AR-07-1162

Southern Nuclear Operating Company
Vogtle Early Site Permit Application
Supplemental Response to Requests for Additional Information on Geology/Seismology

Supplemental Response to Geology/Seismology RAIs

Vogtle ESP Application

SNC Time History Matches: 10-4, High Frequency

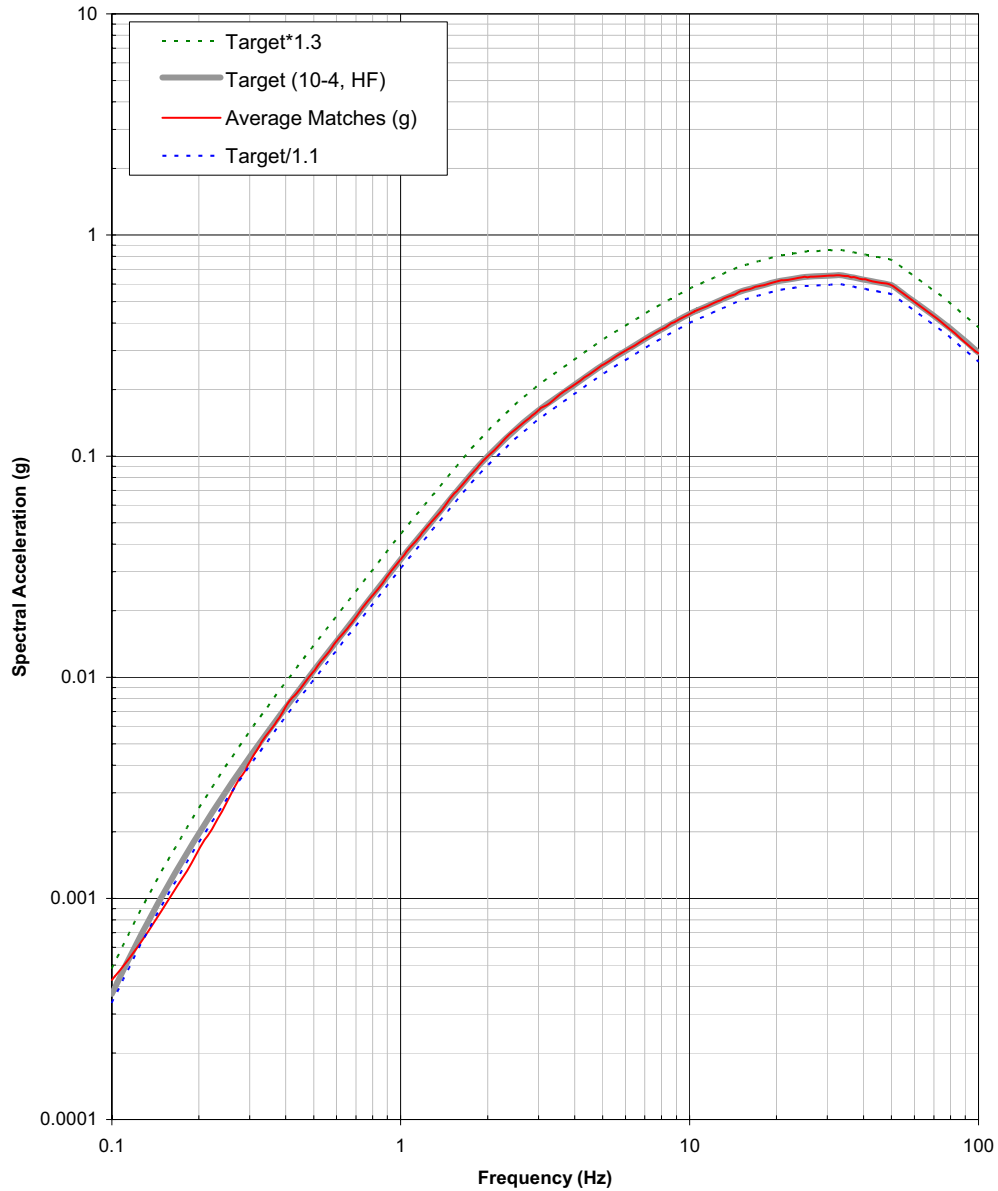
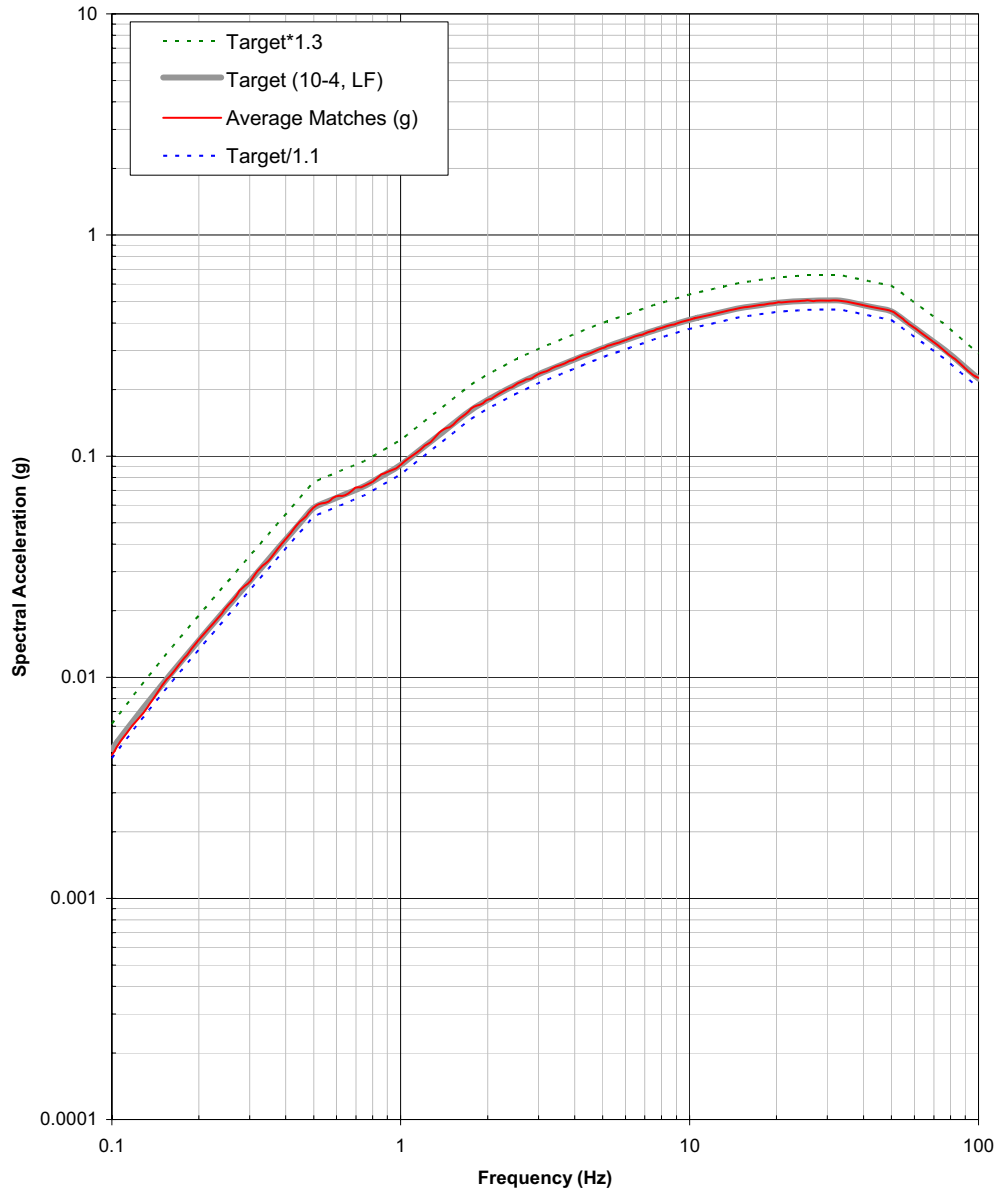
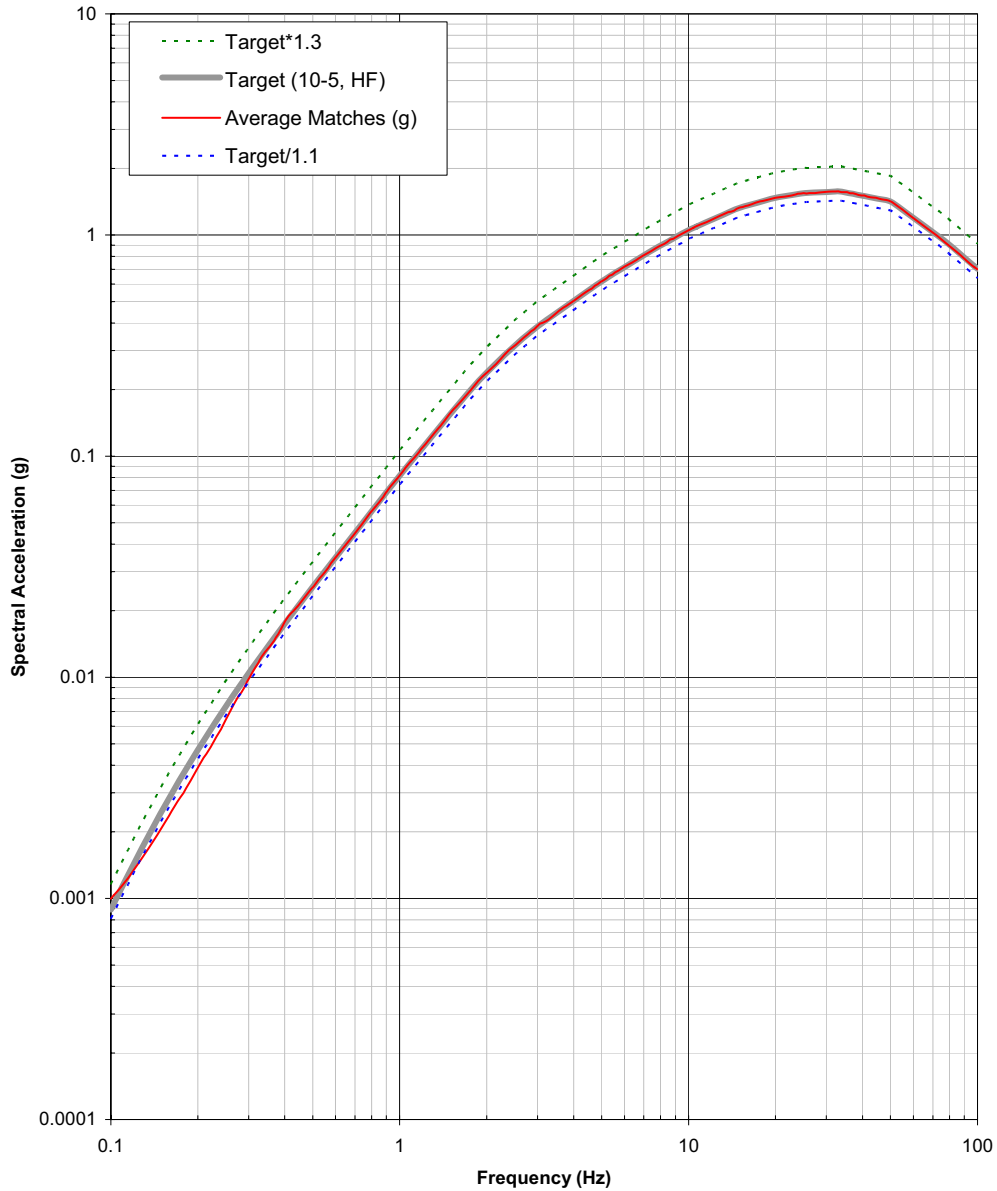
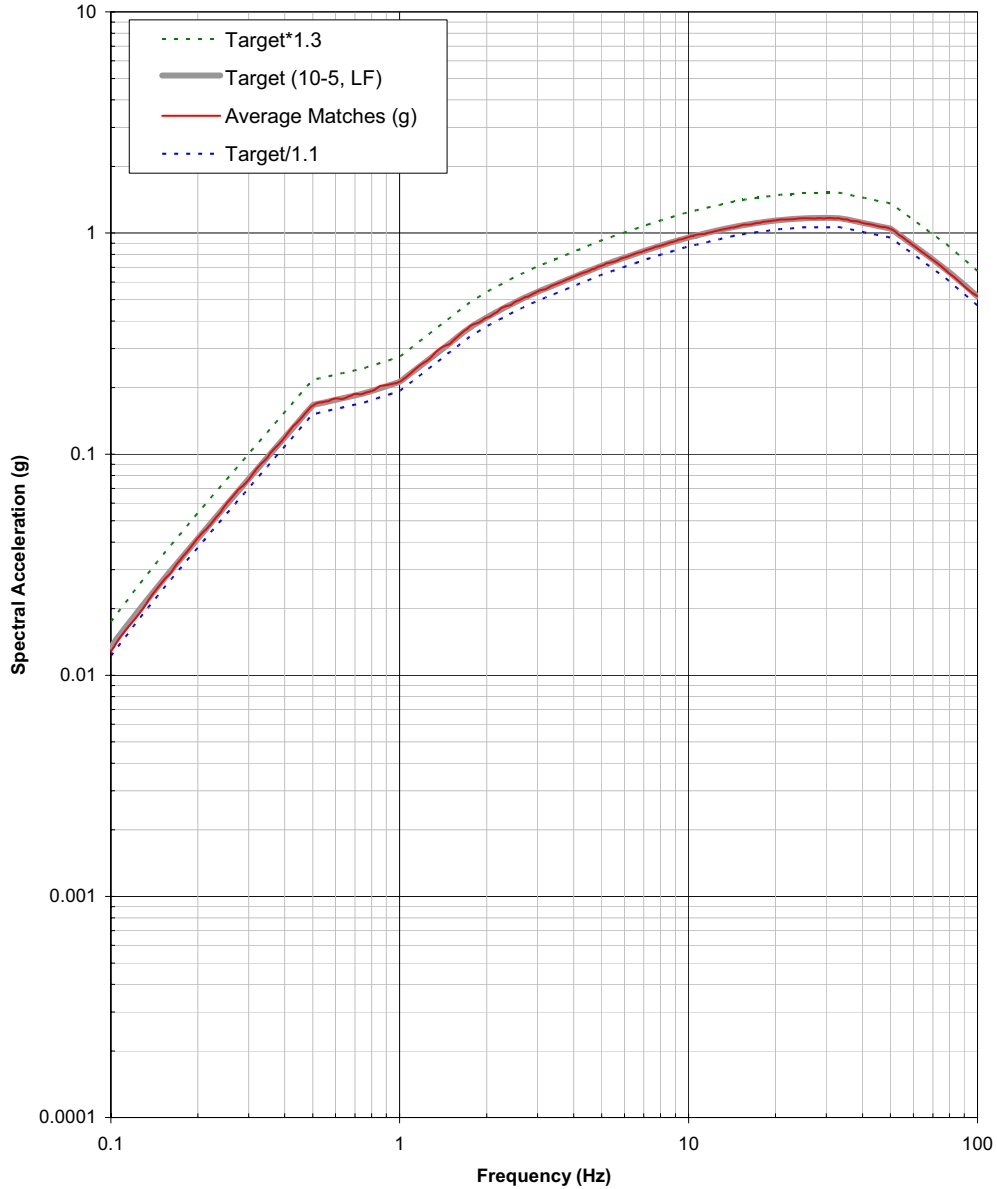
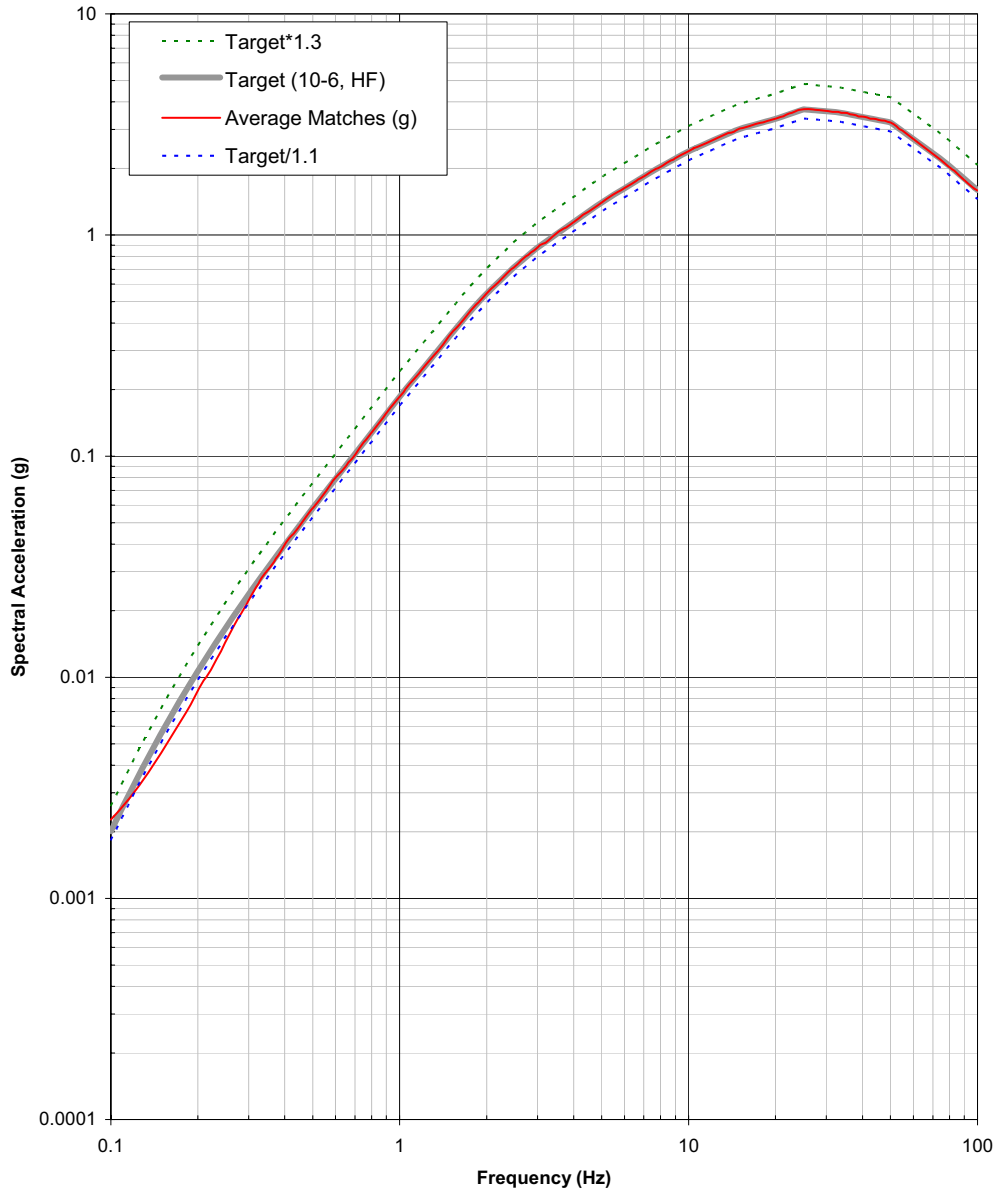
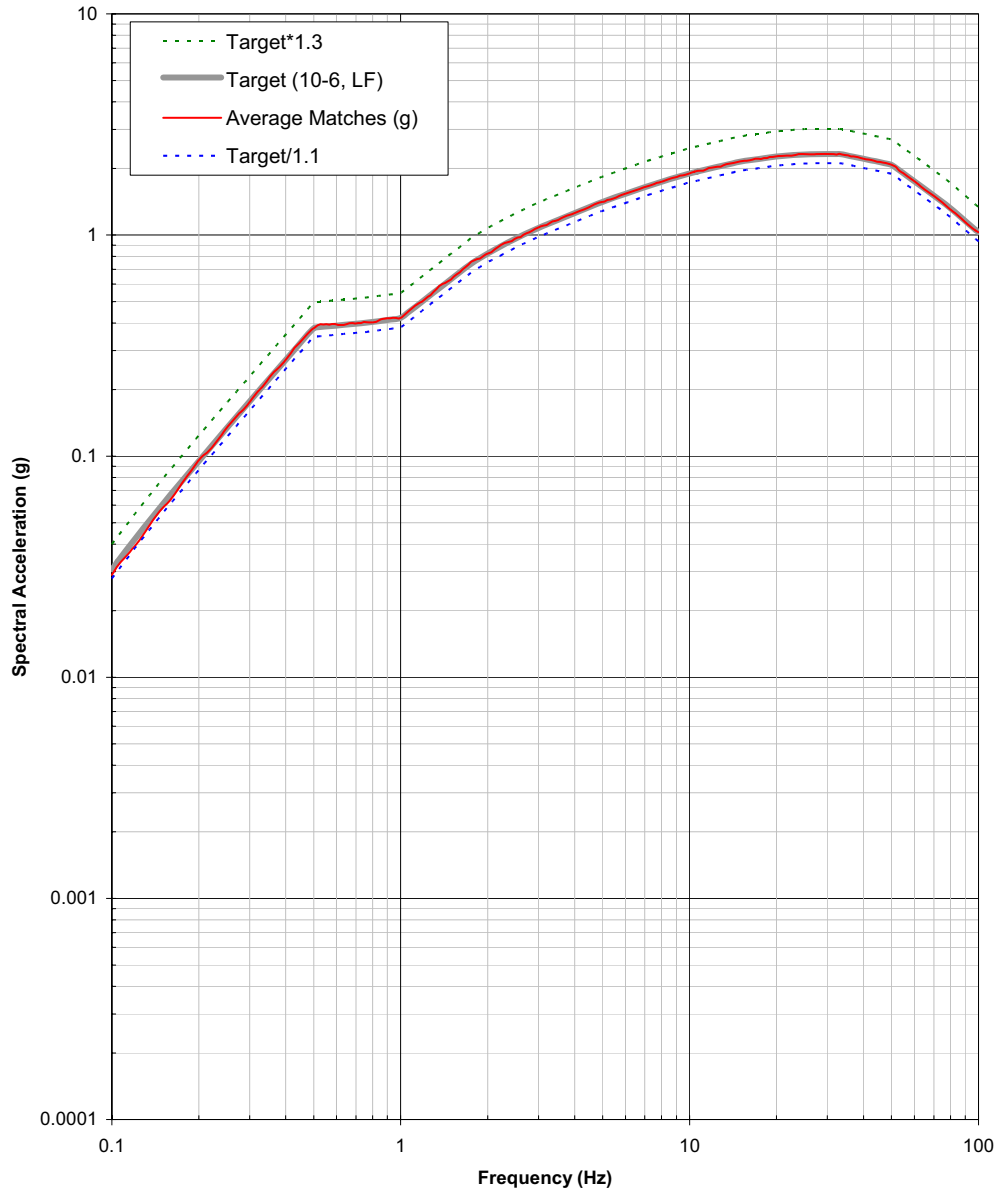
Please explain whether the additional criteria listed in NUREG/CR-6728 were also satisfied. If these additional criteria were not satisfied, please provide justification for not doing so.

For the site response analysis, 30 acceleration horizontal time histories were modified to be spectrum compatible to given target spectra. Target spectra were developed for both the high- and low-frequency cases at each of the three annual probability levels: 1×10^{-4} , 1×10^{-5} , and 1×10^{-6} . This resulted in a total of 180 spectrum compatible acceleration time histories for the site response analysis. For a given suite of 30 time histories, the spectral matching criteria given in NUREG CR-6728 were used as guidance.

As specified in the NUREG CR-6728 spectral matching criteria, when using multiple sets of time histories, the mean (linear average) of the 5% damped response spectra (in this case for a given suite of 30 matches) can be used in place of the individual 5% damped response spectra for checking against the target response spectra. Criteria (a), (d), and (e) define the matching requirements for the mean response spectra and the given target response spectra. These criteria are defined for the frequency range of 0.2 to 25 Hz. For the three low frequency cases (i.e., 10^{-4} , 10^{-5} , and 10^{-6}) the mean of the suite of spectrum

Finally, criterion (g) was not checked because it does not apply. The site response analyses were performed for a single horizontal component not pairs of horizontal components.
